Interactive comment on “Assessing the hydrologic restoration of an urbanized area via integrated distributed hydrological model” by D. H. Trinh and T. F. M. Chui

Received and published: 28 July 2013

Fig. 1. Water balance aggregated over one year for different scenarios with a lower soil hydraulic conductivity

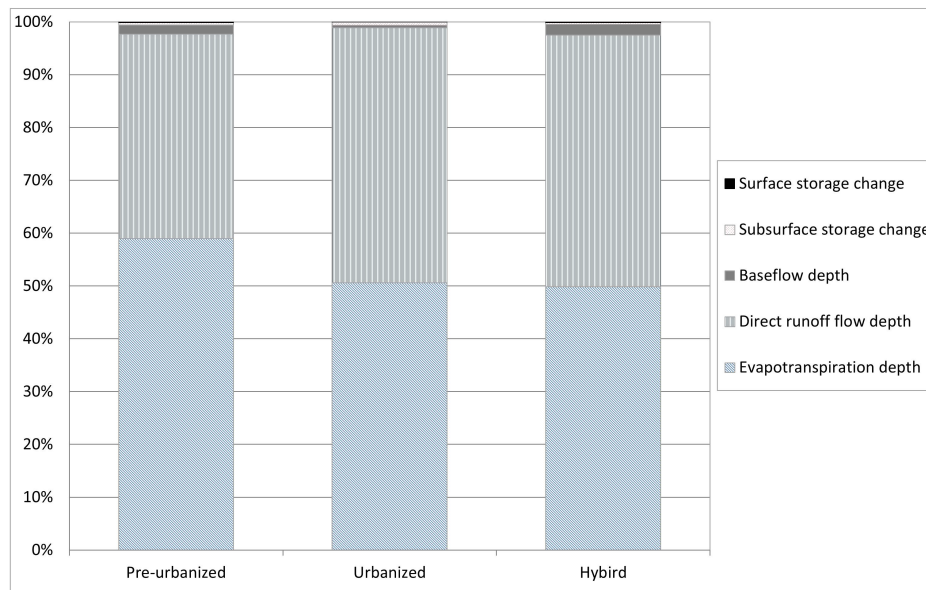
2. The main concern about the reviewed paper is related to an absolute lack of any observation data (apart from meteorological data), and all presented results and discussion are solely based on the model outcome. This is the main limitation of the suggested results: the model doesn't seem to be validated at all. In couple models, rainfall partitioning to recharge and runoff is depended on the soil properties, and it is very sensitive to unsaturated zone parameters. Incorrect partitioning, resulting from inadequate parameters selection propagates the error to simulated river flow. How much trust one can put in the model outcomes, when no evidences were offered on whether the model treats the rainfall partitioning correctly? Even in relative terms, the analysis of difference between selected scenarios on baseflow or peak flow could be wrong.

We understand and acknowledge that our models, without calibration and validation, are not producing the exact and precise responses of any particular system. Instead, we are hoping to develop general understandings on the overall effects of green structures using the physically based models with realistic choice of parameters, and that the generic results and insights are more widely applicable, as we have stated on p. 4105 lines 19-26 and on p. 4118 lines 1 to 5. We also agree with Dr. Barron that rainfall partitioning to recharge and runoff is sensitive to soil properties. We therefore simulate the different scenarios with a soil hydraulic conductivity that is one order of magnitude lower. For the aggregated water balance over one year (Fig.1), the rainfall partitioning still follows the same patterns as the original simulation. For example, when compared with the pre-urbanized scenario, there is still close to a 10% increase of direct runoff and 10% decrease in evapotranspiration in the urbanized and hybrid scenarios. There is also more baseflow in the hybrid scenario when compared to the urbanized one due to the green structures. In terms of peak outlet discharge (Fig.2), the low hydraulic conductivity leads to an increase of peak discharge by 50 m³/s in the pre-urbanized scenario. Similarly, the decrease in hydraulic conductivity also results in a higher peak discharge in the hybrid scenario. However, the amount of increase, 100 m³/s, is higher than pre-urbanized one. This is because the low hydraulic conductivity of the native soil not only reduces rainfall infiltration but also limit the exfiltration of the bio-retention system. The change in hydraulic conductivity however does not significantly affect the peaks in the urbanized scenario due to the low percentage of pervious area. Although the absolute values of peak discharges change with the hydraulic conductivity, the relative differences among the scenarios are still the same. In other words, there is still a drastic increase of peak discharge in the urbanized scenario and a partial recovery in the hybrid one. In conclusion, although the change in hydraulic conductivity leads to some changes in the model results in terms of the aggregated water balance as well as the absolute values of outlet peak discharge; the main observations of how urbanization influences hydrological conditions and how green structures restores it are still the same. Thus, we believe that the model outcomes are reliable for drawing the main
